Development & Heritage Standing Committee Meeting Agenda

Date: Tuesday, August 5, 2025

Date to Council: August 5, 2025
Author: Frank Garardo
Planner III - Policy & Special Studies
519-255-6543 (ext. 6446)
Planning & Building Services
fgarardo@citywindsor.ca
Planning & Building Services
Report Date: July 7, 2025
Clerk's File #: Z/14993

PROJECT:
2121 RIVERSIDE DRIVE W. APARTMENTS
Windsor, Ontario

DRAWING TITLE:
PRELIMINARY SITE PLAN
SCALE: 1:100
ACAD REFERENCE: 4758 –P1– Site Plan

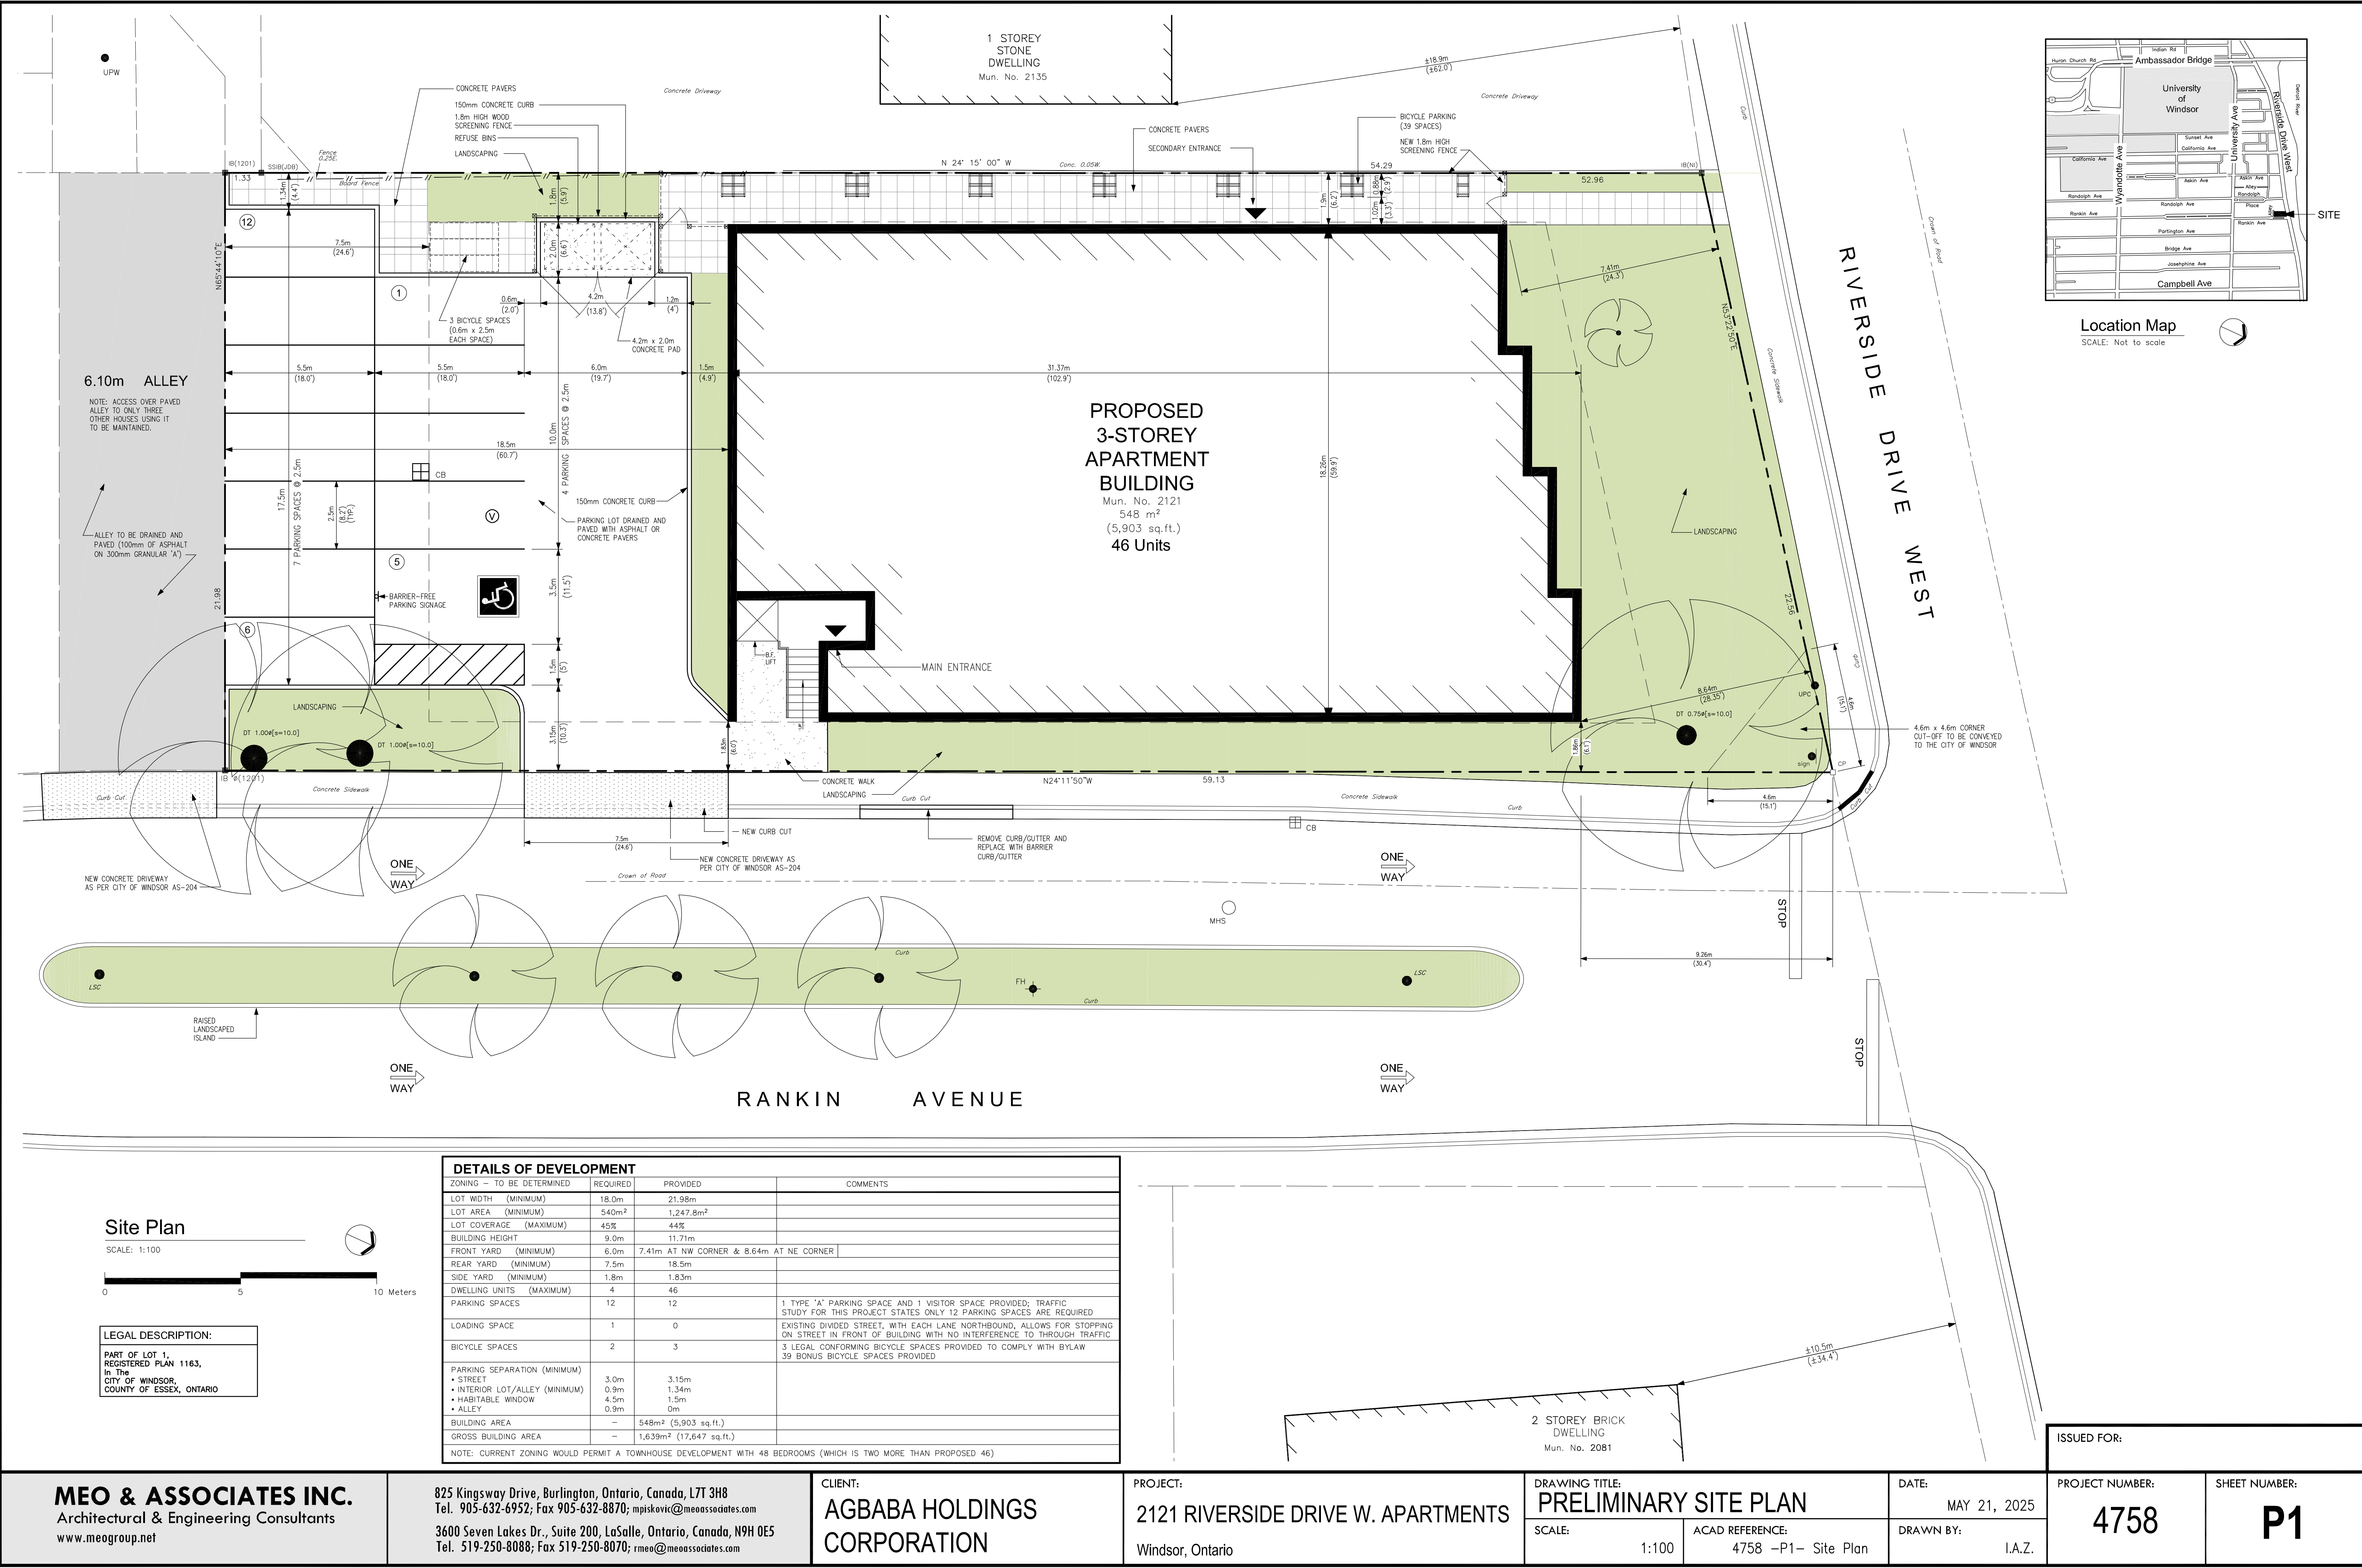
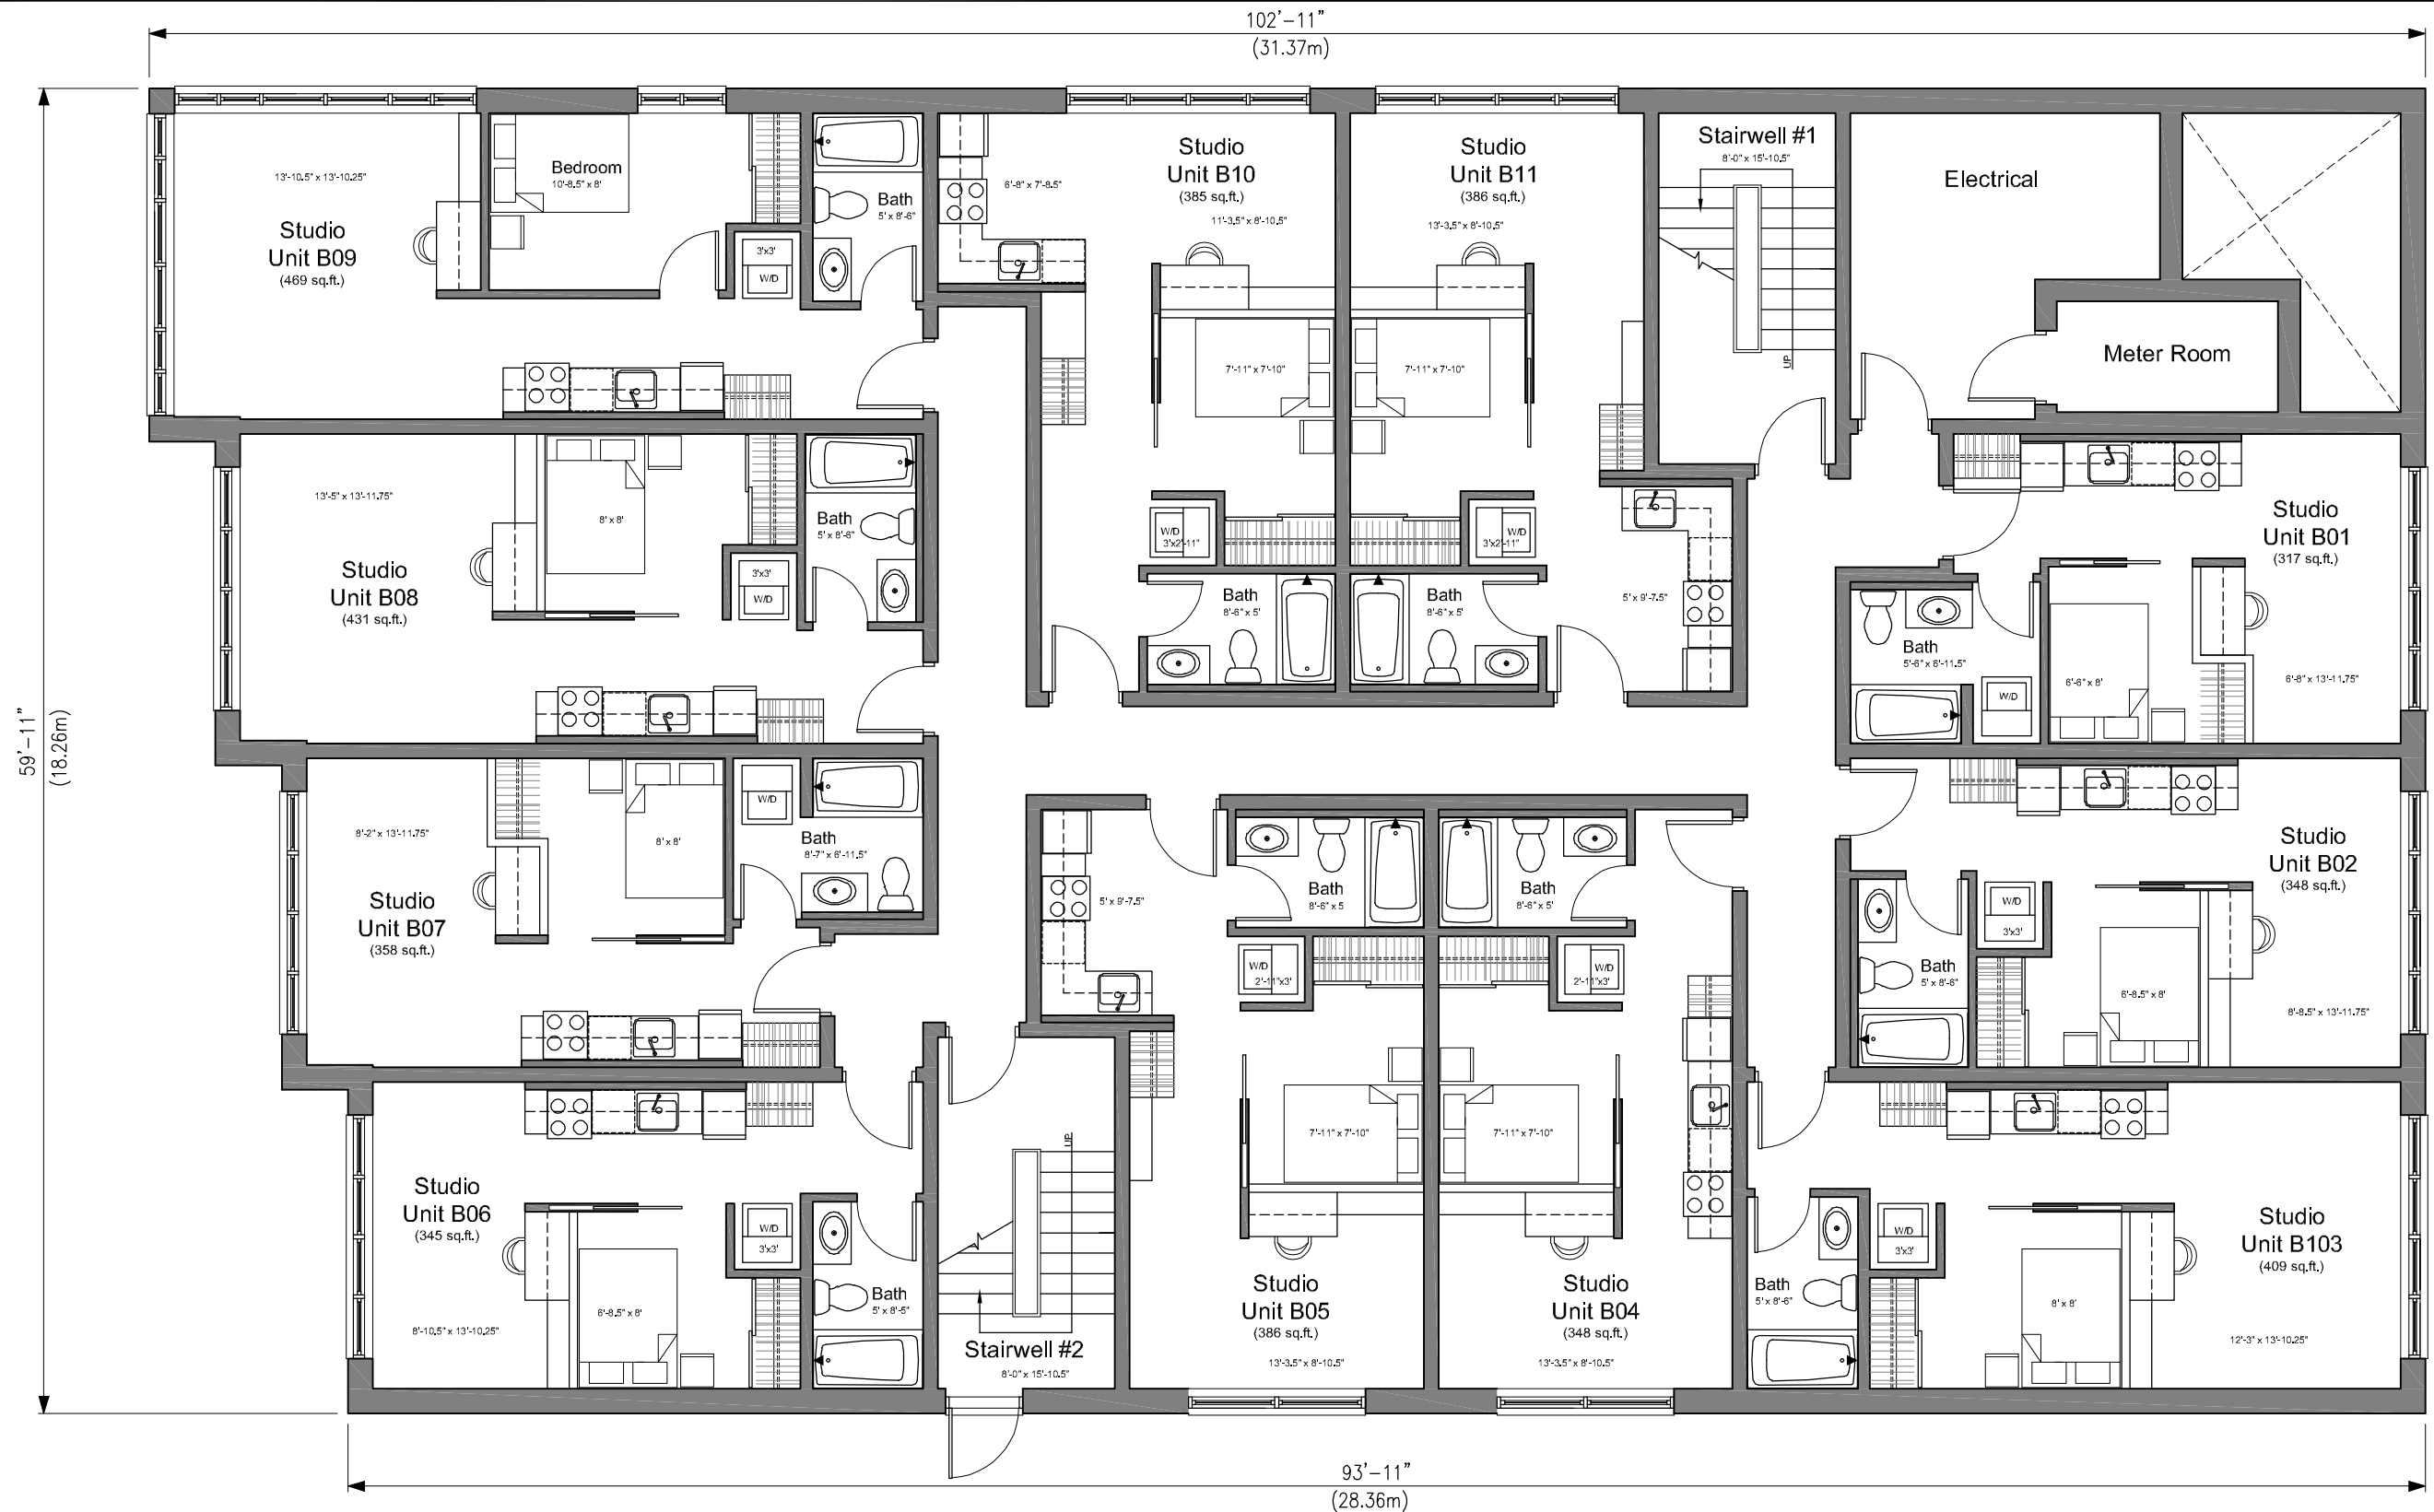
Provision	RD2.2 Requirements	Proposed	Comments
Permitted Building Type	One multiple dwelling containing a maximum of 4 dwelling units	One multiple dwelling containing 46 dwelling units	Exceeds permitted use under RD2.2. Administration does not concur with the Planning Rationale Report identifying a site specific RD2.2 low density zoning category, while increasing the use to a high density impact.
Building Height (max) (Sec. 11.2.5.4.4)	9.0 m	11.7 metres (habitable), 14.0 metres (including mechanical)	Exceeds height limit. Consider transition guidelines. The City of Windsor Zoning by-law permits heights in excess of three storeys in certain scenarios; however setbacks are tailored to meet adequate separations, amenity spaces, and site configurations.
Dwelling Unit Density	Max. 4 dwelling units	46 dwelling units	The proposed development, comprised of 46 dwelling units on site yields a density of 375 units per net hectare, significantly exceeds the City of Windsor Official Plans framework for residential intensification. This density level far surpasses not only the current RD2.2 zoning allowance of 25-35 units per net hectare, but also the thresholds typically associated with high-density residential development supported in the City Centre or Mixed Use Centres. High-density developments of this scale are generally located on substantially larger parcels of land. The proposed rezoning to a site-specific high-density designation introduces a level of intensification that is inconsistent with the

Provision	RD2.2 Requirements	Proposed	Comments
			existing planning framework and out of scale with the surrounding context. As such, the application represents a form of overdevelopment that conflicts with the City's Official Plan objectives and established zoning provisions.
Lot Size	540.0 square meters	1247 square meters	The RD2.2 lot size requirements are tailored to a maximum of four dwelling units. Comparable multi unit developments with similar lot sizes include 1933 Riverside Drive West, 1805 Riverside Drive West, 2220 University Ave W, with units ranging from 10-15 or just over 100 units per net hectare. Multiple-unit developments with over 200 units per net hectare include 275 Askin Ave, 260 Randolph Place, 140 Bridge Avenue, however each of these have characteristics of a lot size which is significantly larger than the subject parcel.
Front Yard Depth (min)	6.0 m	7.4 m	<p>Although the proposal meets the front yard depth for low density development. The proposal includes an increase in built form which will be located much closer to the front yard then abutting properties.</p> <p>The City of Windsor Intensification Guidelines encourage a minimum front yard depth which represents the lot averaging between the adjacent buildings. The proposed front yard depth is not consistent with the guiding principles of the City of Windsor Intensification guidelines.</p>

Provision	RD2.2 Requirements	Proposed	Comments
Parking Requirement (Sec. 24.20.5)	1.25 spaces/unit = 57 spaces	12 spaces	Deficient by 43 spaces. Not supported by Transportation Planning. The proposed number of parking is not adequate for the proposed development. Therefore, Transportation Planning is not in support of the proposed dramatic reduction in required parking.
Bike Parking	2 spaces	43 spaces	Any reduction to bicycle parking space size and locations are not supported. The bicycle parking spaces are located in a required side yard which create accessibility concerns and is not permitted by the Zoning By-law.
Loading Space (Sec. 24.40.1.5)	1 space	0 spaces	Loading spaces are required for multiple dwellings. The proposal identifies an increase of units, while removing loading spaces. This contributes to inadequate site accessibility.
Parking Space Setback (habitable window) (Sec. 25.5.20.1.6)	4.5 m	1.5 m	Not Supported. The proposal will include a significant increase in vehicular and pedestrian traffic while reducing separation between entrances, habitable windows and parking areas. This is a concern for site configuration and accessibility.
